94 22 Bunz
Site Plan Rt. 207

SUBJECT: BUNZ SITE PLAN
SITE COMPLETION REVIEW
NEW WINDSOR PLANNING BOARD NO. 94-22

**TOWN OF NEW WINDSOR
PLANNING BOARD
REVIEW COMMENTS**

REVIEW NAME: BUNZ SITE PLAN
(FORMERLY PICNIC PALACE APPLICATION)
PROJECT LOCATION: NYS ROUTE 207
SECTION 3-BLOCK 1-LOT 32.2
PROJECT NUMBER: 94-22
DATE: 24 AUGUST 1994
DESCRIPTION: THE APPLICATION INVOLVES A PROPOSED EATING AND
DRINKING ESTABLISHMENT AT THE SITE PREVIOUSLY
REVIEWED AS THE "PICNIC PALACE".

HANDICAPPED SPACE DETAIL
SCALE: 1"=10'

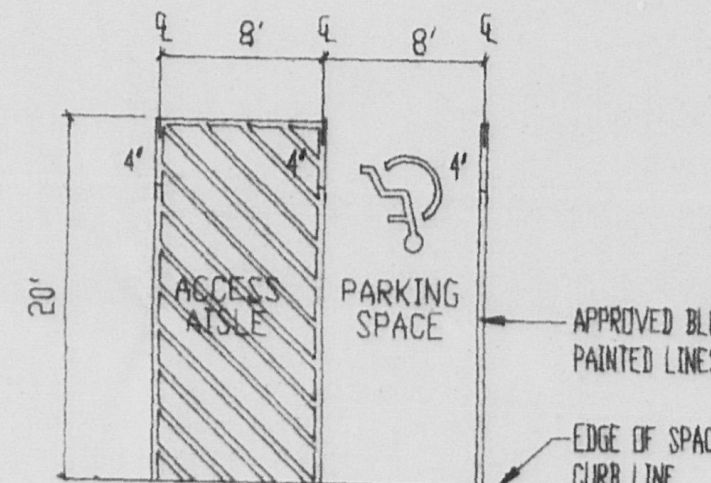
7. It is my understanding from our review that the current condition of the ramp, as installed, is unacceptable and violates the State Code. This problem results from the "extension" of the ramp slope utilizing concrete beyond the wooden ramp, without the benefit of the side railings. Apparently, a problem also exists with regard to the ramp surface not including a lip to prevent wheelchairs from rolling off the edge of the ramp surface.

SITE PLAN

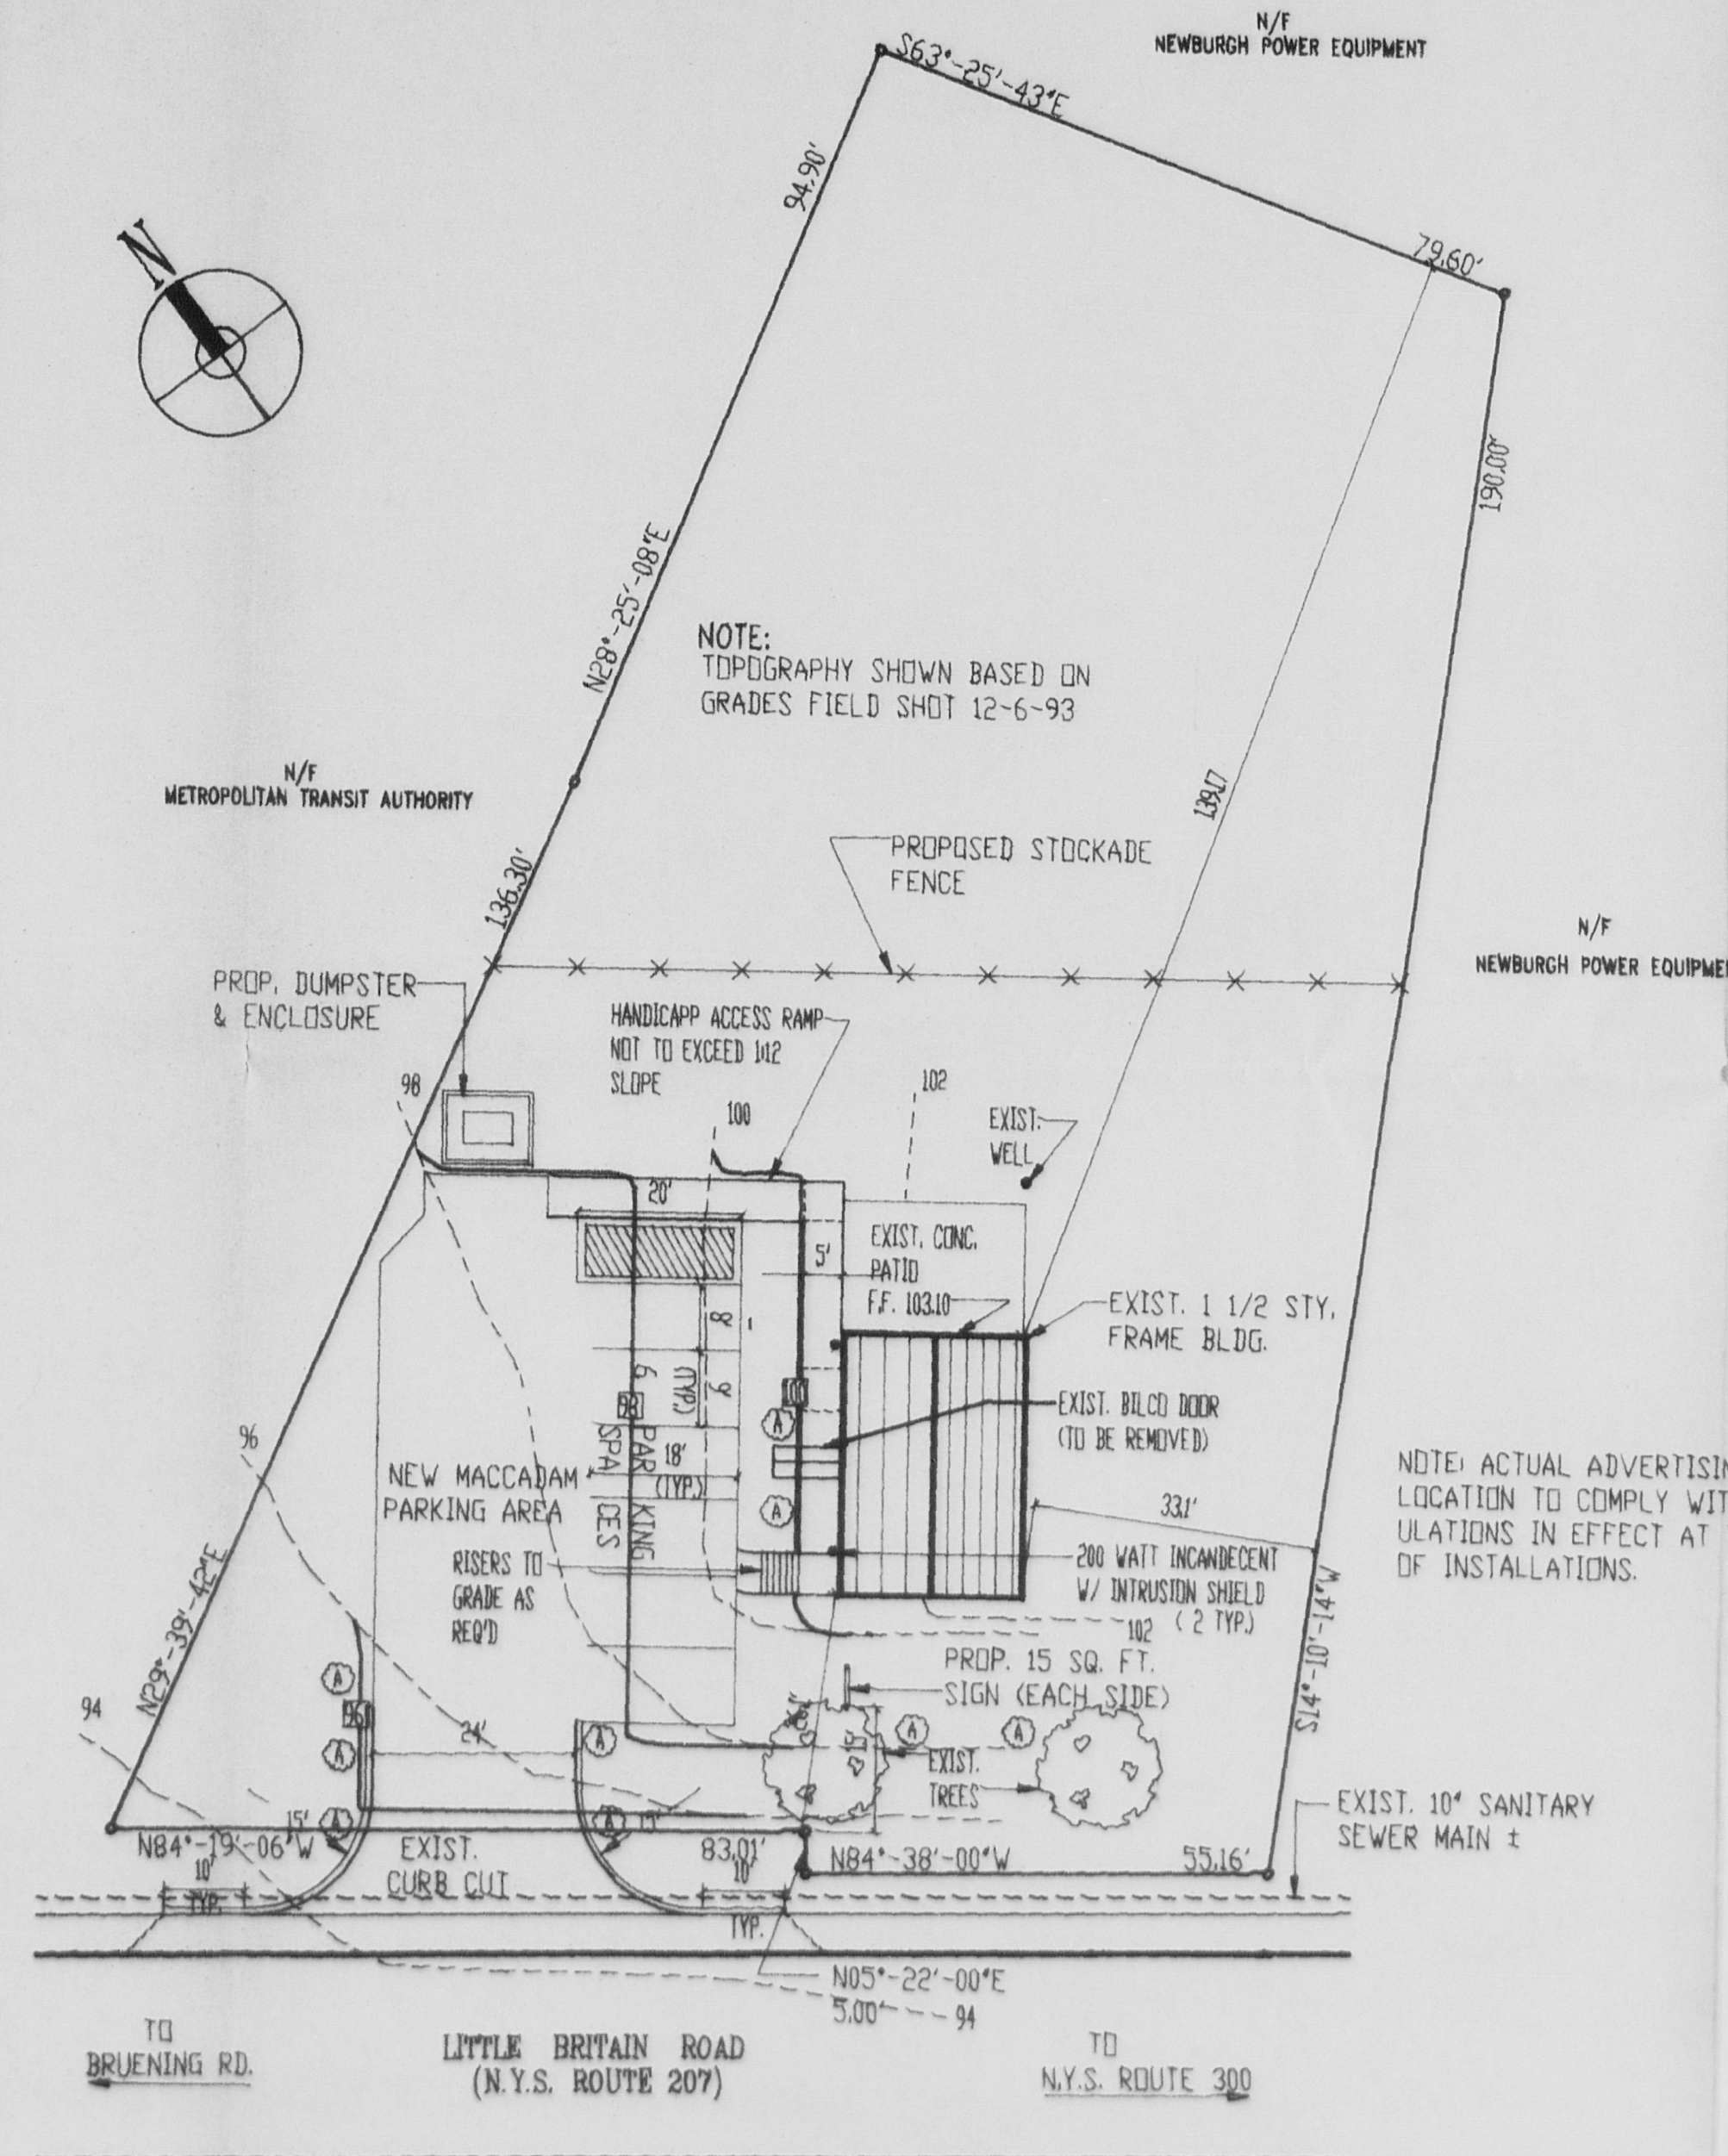
1. The handicapped ramp was constructed with a different configuration and different location than that shown on the plans. The ramp is approximately 9' spaced from the building, rather than immediately adjacent to the building, as was indicated on the approved site plan. Further, the length of the ramp has been significantly shortened by at least 35+', with the ramp now terminating to the right side of the handicapped parking space. These changes have resulted in some problems as further listed below.

2. Due to the location of the ramp, it is likely that vehicles parking in the marked spaces will hit the ramp structure with their bumpers (Previously a landscaped area existed between the parking spaces and the ramp. This area now exists between the ramp and the building). It may be appropriate to install wheel stops to avoid damage to the wooden ramp.

3. The striping of the parking spaces is unacceptable. Six (6) parking spaces were to be provided. Per Town Code, 10' width is required. The striping, as completed, includes six (6) 9' spaces plus one (1) 8' space. Striping length should also be corrected to 20'.

4. The handicapped parking space does not have the required handicapped sign installed.
5. The dumpster pad and dumpster enclosure have not been installed.

6. The plantings at the front of the site have not been installed as shown on the approved plan. The evergreens have been installed in the State right-of-way and already pose a hazard in that line of sight is already obstructed when existing onto the State highway. These plantings should be relocated away from the State highway, onto the private property and out of sight line.

It was also observed that a light fixture has been installed on the exterior of the building near the parking area. This lighting fixtures does not appear to be the type and location as shown on the approved plan; however, given the commercial nature of the surroundings, this does not appear to be an area of concern.
